DEVIATION REQUEST AND DECISION FORM

PROJECT INFORMATION – NEW LOG ROAD DEVIATION REQUEST

Project Name : Mayberry, Colorado Springs Filing No. 1
 Schedule No.(s) : 34000-00-259, -260, -349, -350, -356, -362
 Legal Description : Mayberry, Colorado Springs Filing No. 1

SHEET: **TY1**

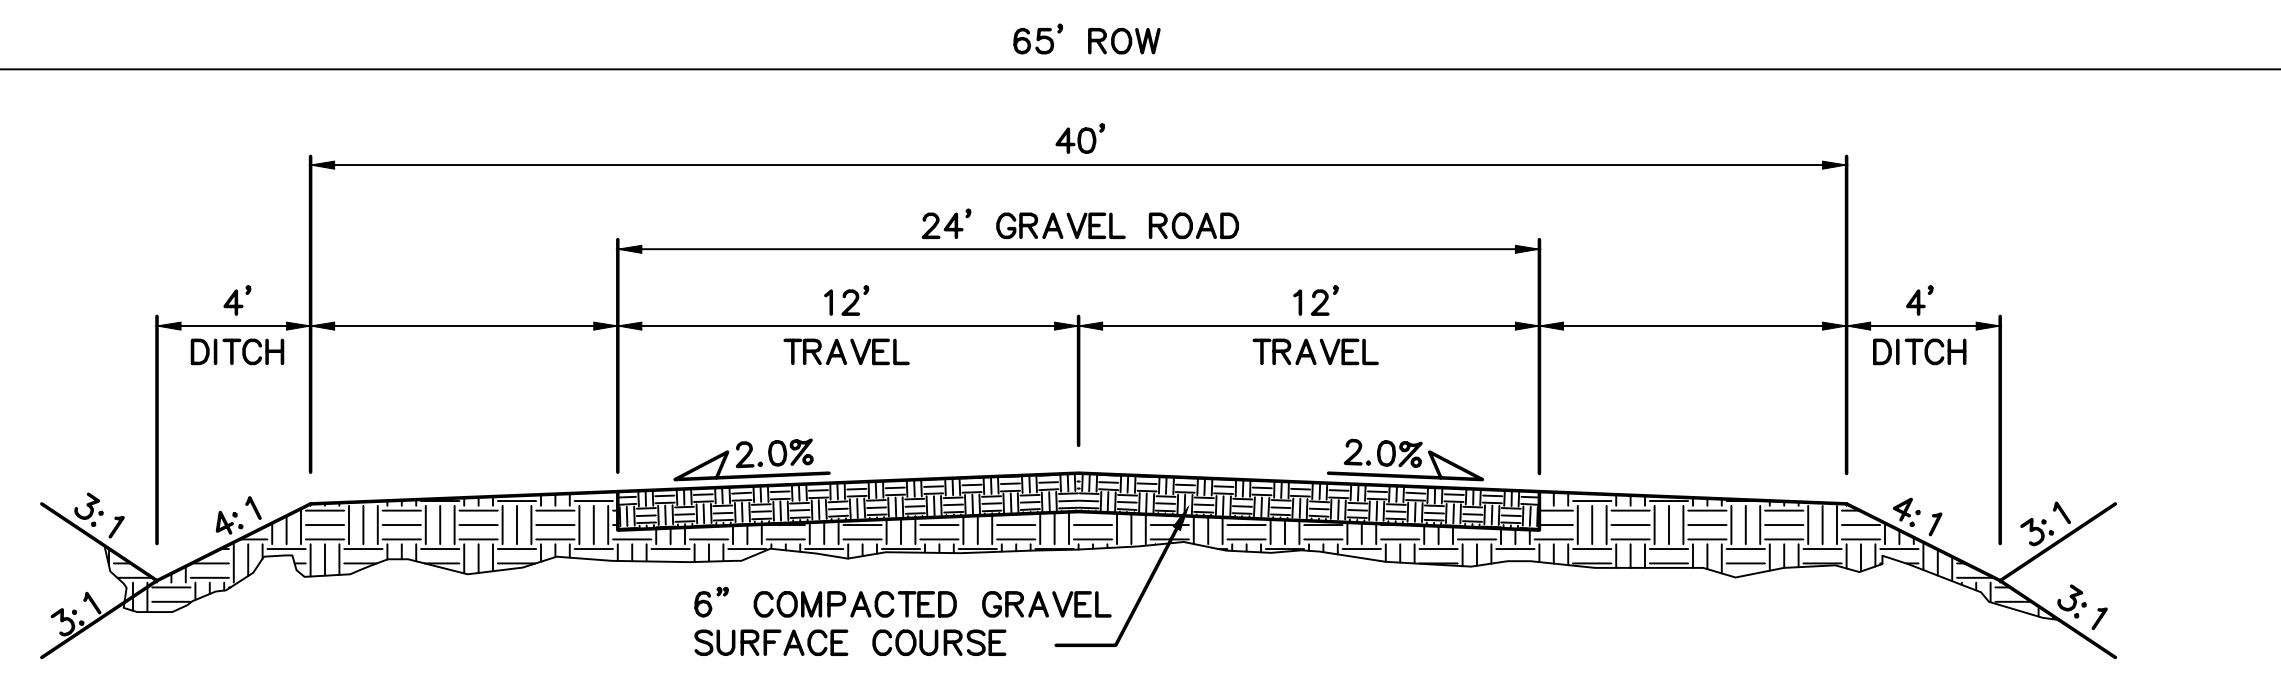
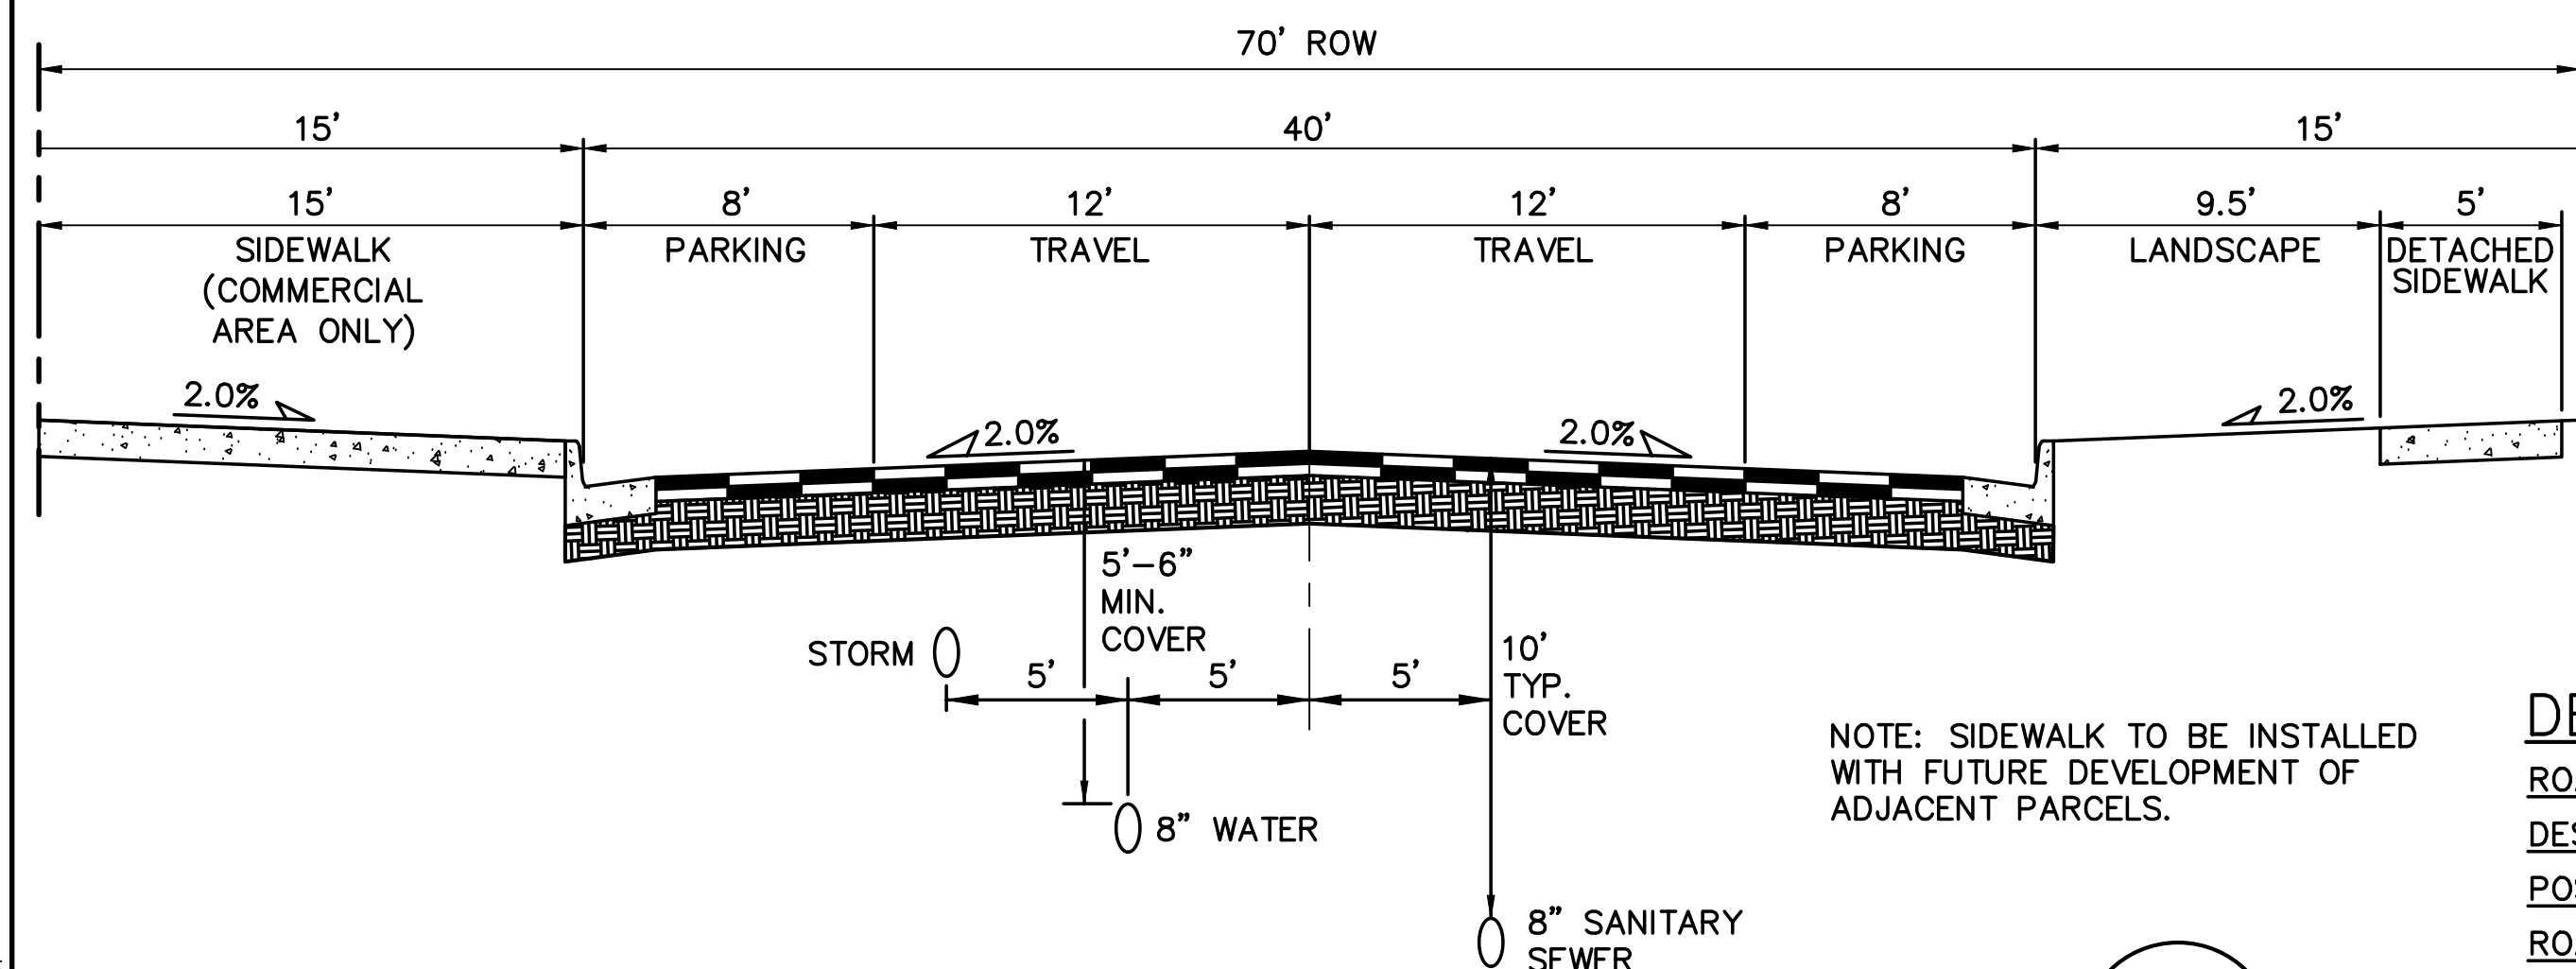
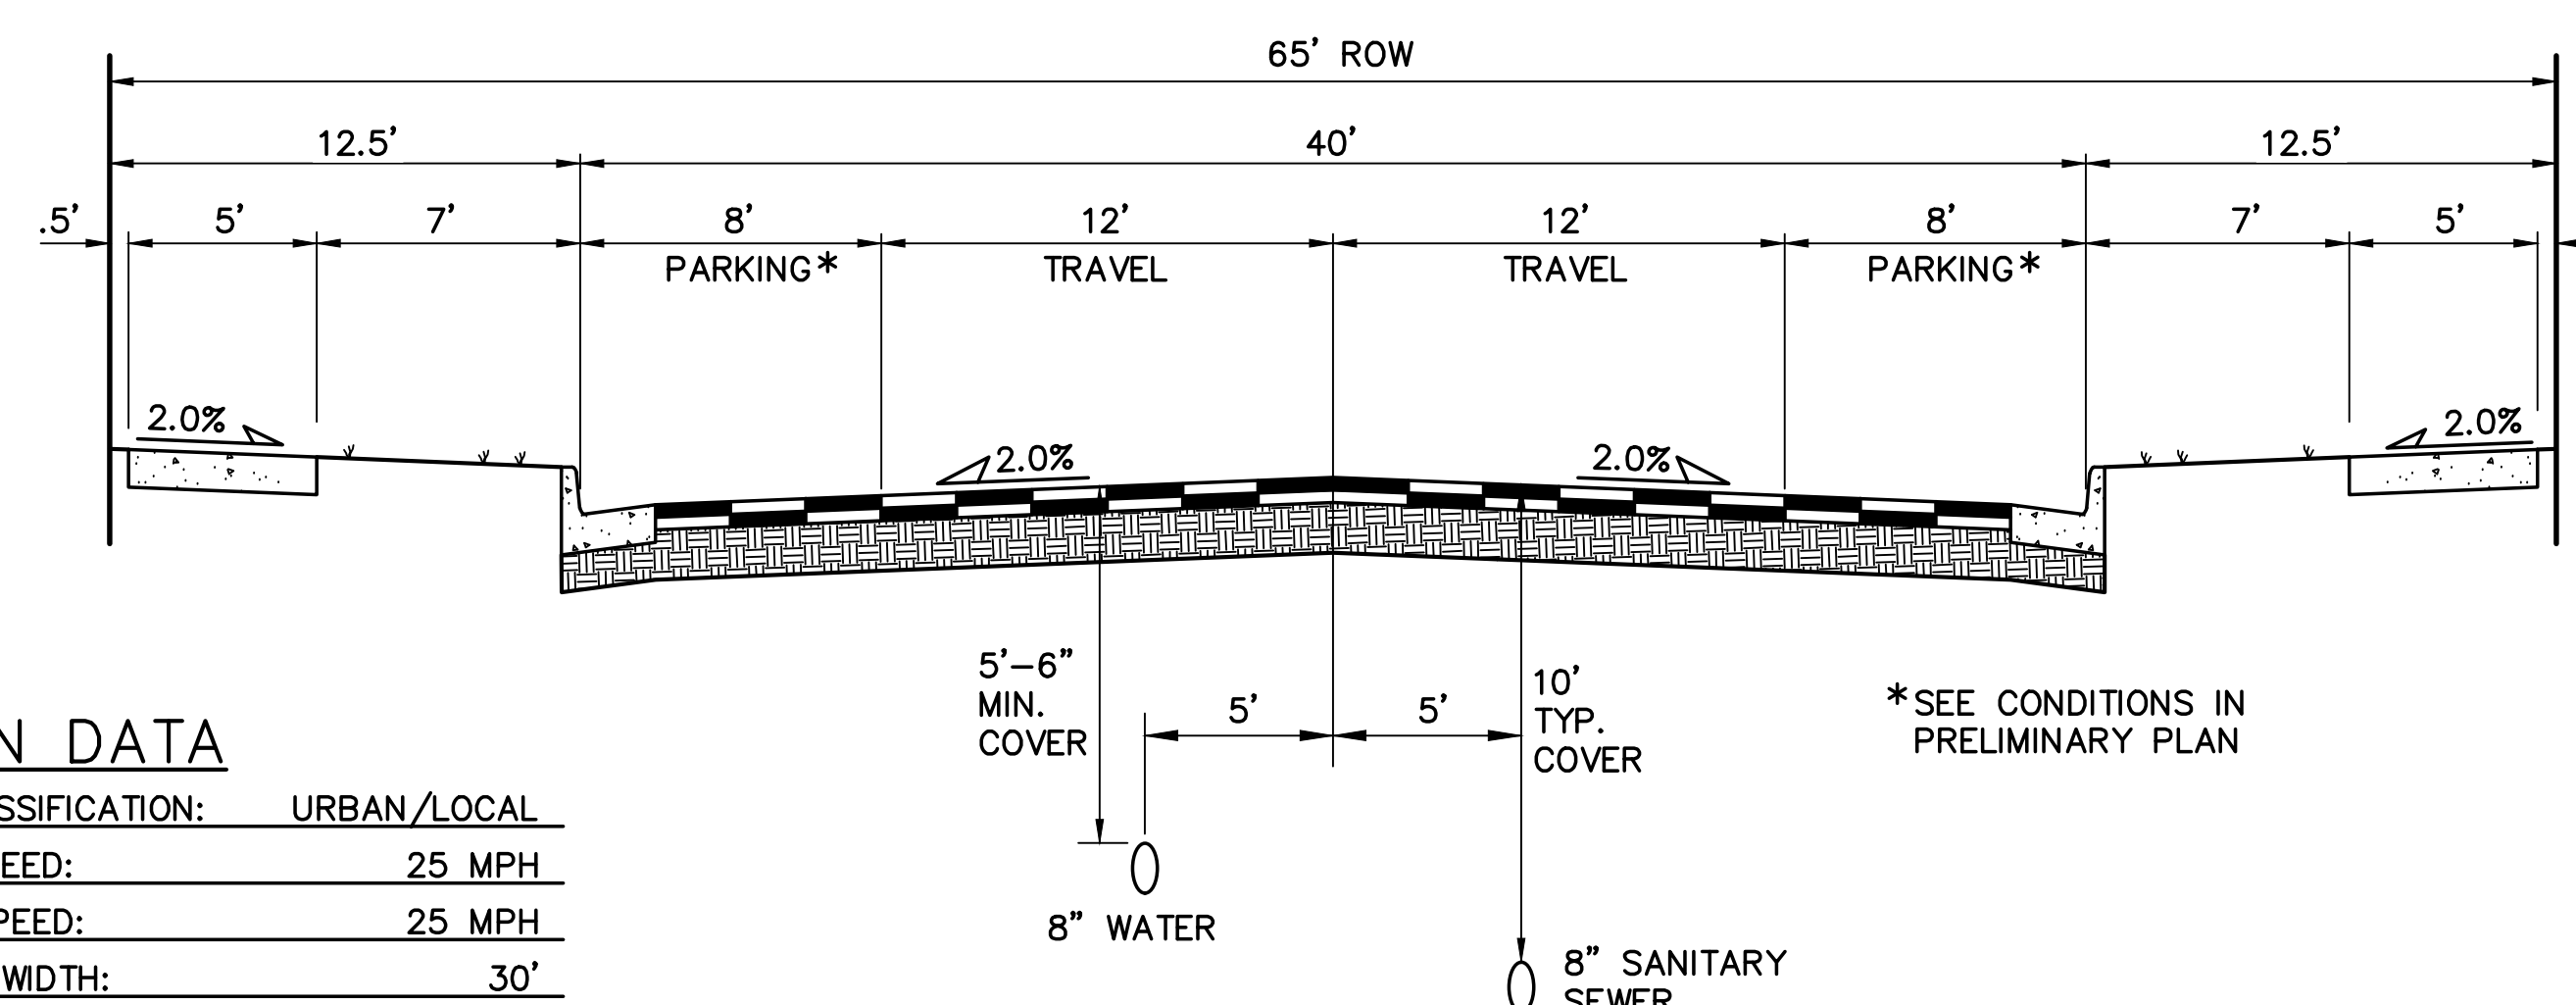
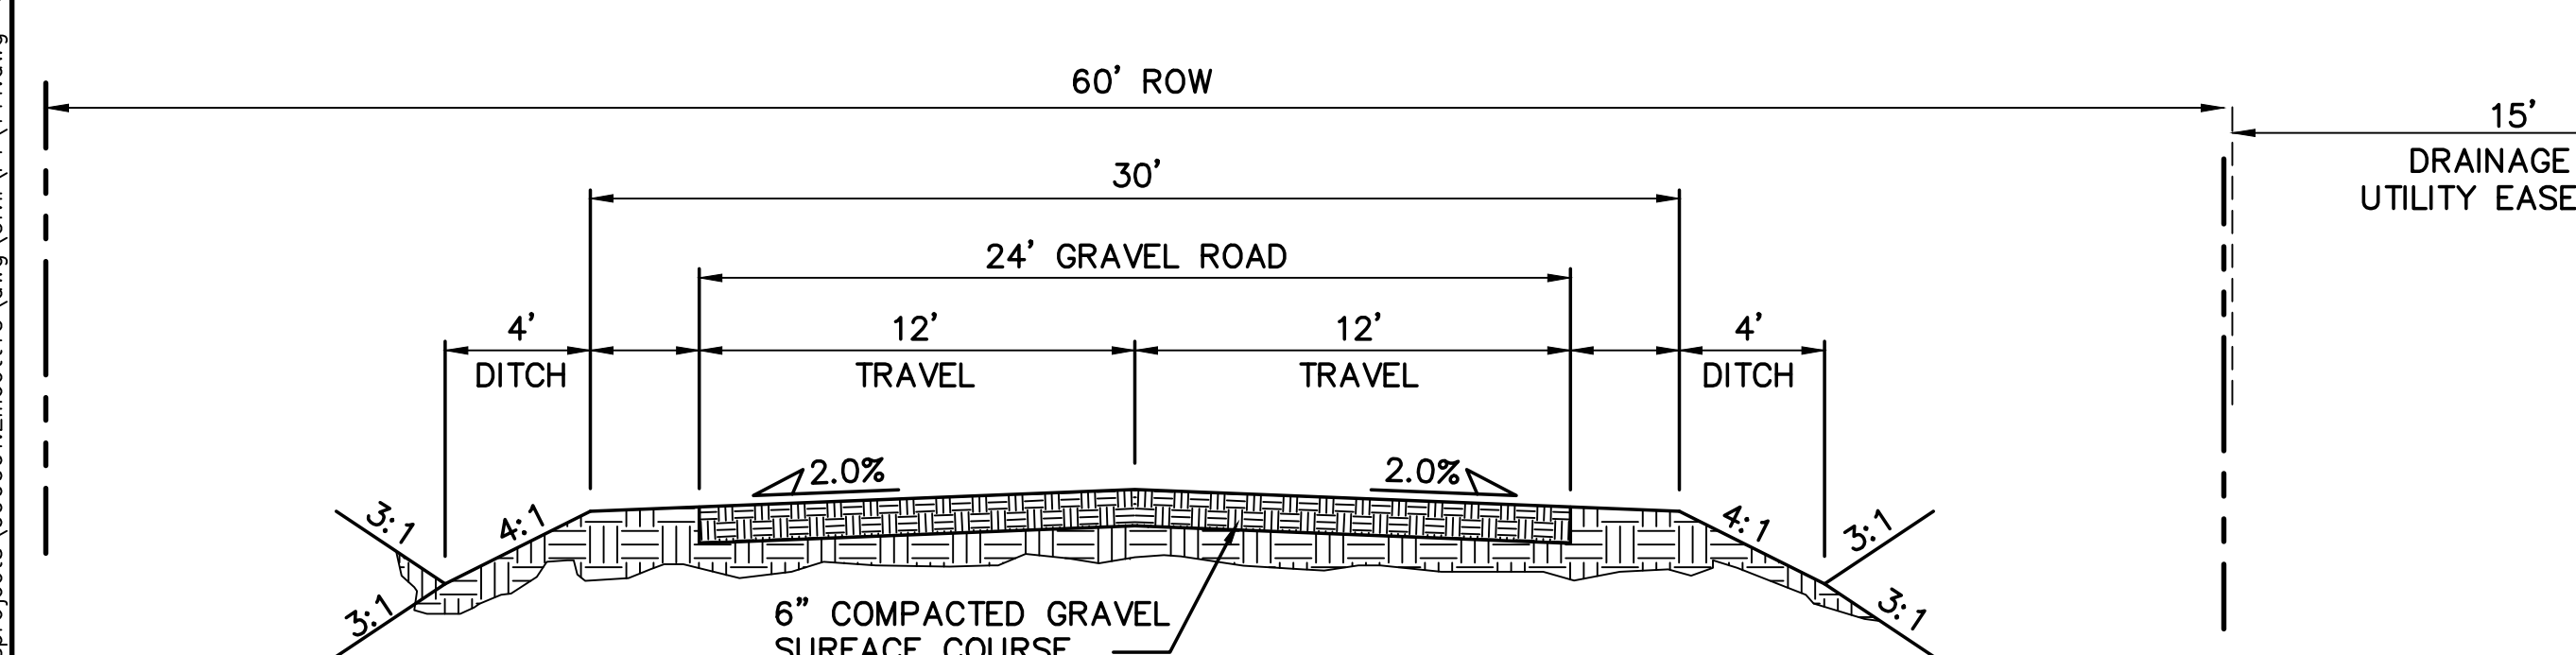
Village Main Street is ultimately classified as an Urban Non-Residential Collector through the Town Center area, and an Urban Residential Collector through the residential areas. The proposed deviations consist of modified cross-section elements including a 36-foot asphalt width for the Non-Residential Collector and a 30-foot asphalt width for the Residential Collector road segments, as well as an interim gravel secondary access road section during the initial phase of development. The proposed deviations are depicted on the Typical Road Section Drawings (Sections A-C, Sh. TY1).

The current ECM standard is a 48-foot asphalt width for an Urban Non-Residential Collector and a 36-foot asphalt width for an Urban Residential Collector. The narrower road widths are consistent with new urbanist land planning as approved in the Ellicott Town Center PUD. Minimum travel lane widths of 12 feet are provided in accordance with current ECM standards.
